Atlanta Avenue Railroad Crossing Improvements Emailed Comments Summary

DECREASE CROSSING DISTANCES FOR VULNERABLE USERS.

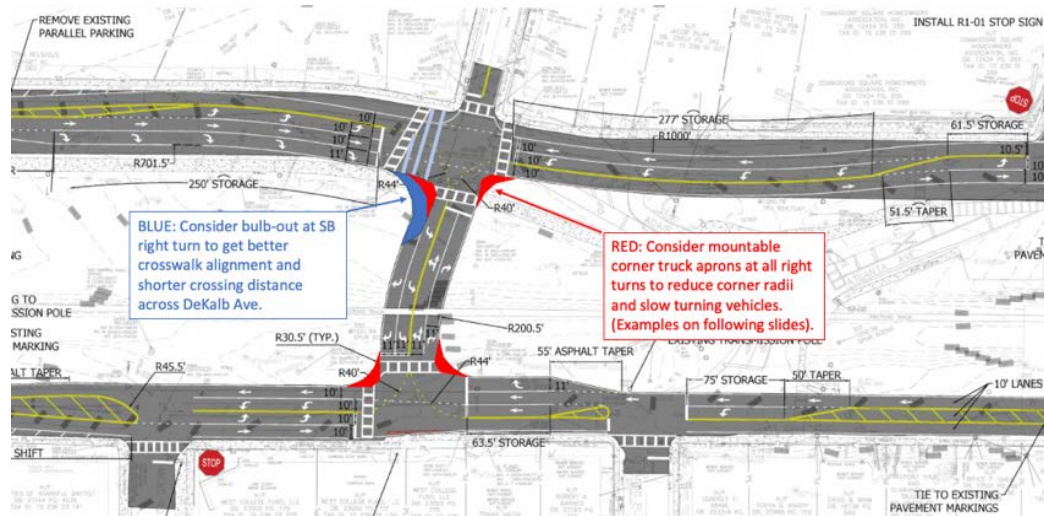
The most significant problem with the plans is the increased crossing distances for vulnerable users. The easiest way to remove this problem is to remove turn lanes. We urge you to reconsider whether all of these new turn lanes are necessary, especially given that there are excellent for motor vehicle crossings very close by, at both McDonough and East Lake (a subterranean crossing). This is the solution we overwhelmingly prefer.

If that is not possible, then there are other ways to reduce crossing distances. One good way is to add bulb outs, perhaps with truck mountable crossing aprons, as follows:

Bulb-outs of this type can go a long way toward protecting vulnerable users by ensuring that crossing distances are shorter and turn radii are tighter (which forces motorists to use safer speeds and pay more attention).

We will continue to evaluate the proposed geometry for optimal performance and safety. We will also include truck aprons at turning radii and consider the bulb-out proposed.

1.2 2. ENSURE DEDICATED RIGHT- AND LEFT-TURN PHASING FOR TRAFFIC SIGNALS.

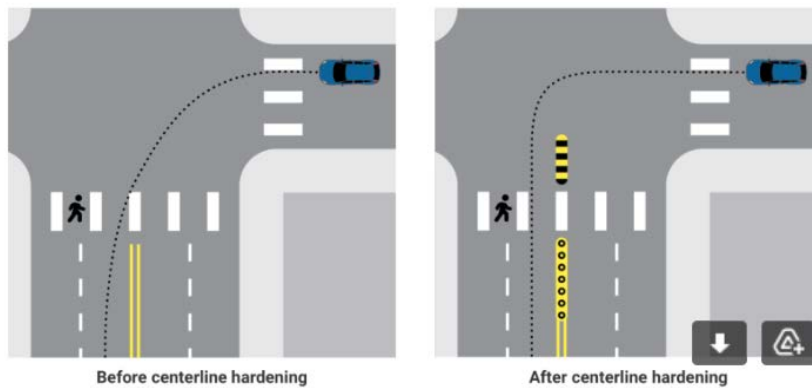
You may already be considering dedicated left-turn phasing, but right turn phasing is also vital. So far as we can tell from the draft plans, the right turn lanes don't currently have their own signal phasing. Instead,

they proceed on the through green signal. This creates a dangerous conflict between walkers/cyclists/wheelchair users on the one hand and motor vehicle users on the other.

The right turn phase will be especially considered for pedestrians and bicyclists with the potential to include on-demand no-right-on-red signals.

1.5 5. ALTERNATE 3 FOR THE CROSSING TRAILS IS PREFERABLE, WITH PROTECTED LANES

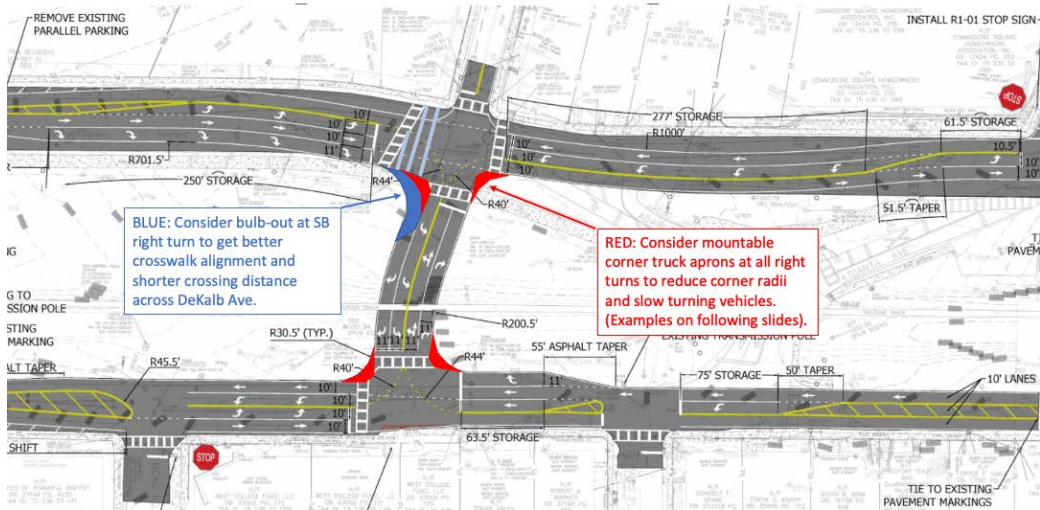
There should absolutely be trails on both sides of the crossing (alt 3). There is no need to increase the conflicts for people walking and cycling by forcing them to cross on a specific side of the street, and any bike/multi-use crossings must be physically protected, not just painted. For years now, the city has acknowledged that multi-use and bike paths should be protected from motor vehicle traffic. So bike/wheelchair facilities should be added to facilitate crossing of the intersections in all directions, and they should have physical protection from motor vehicles.

Thank you for your comments.
